R22 SERVICE BULLETIN SB-106

- DATE: 21 February 2012
- TO: R22 owners, operators, and maintenance personnel
- **SUBJECT:** Rotor Brake Switch

ROTORCRAFT AFFECTED: R22 helicopters S/N 0002 thru 4532.

FIGURE 1

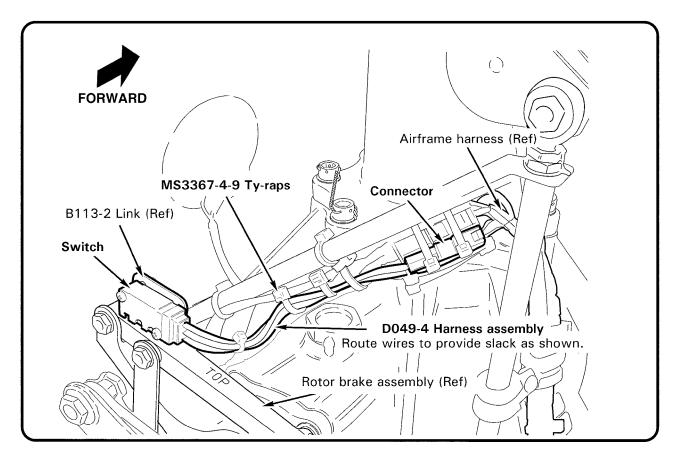
- 5. Refer to Figure 1. Connect D049-4 harness to airframe harness at connectors, routing wires to provide slack as shown. Install MS3367-4-9 ty-raps as required; cinch ty-raps until snug without over-tightening, and trim tips flush with heads. Clean up debris.
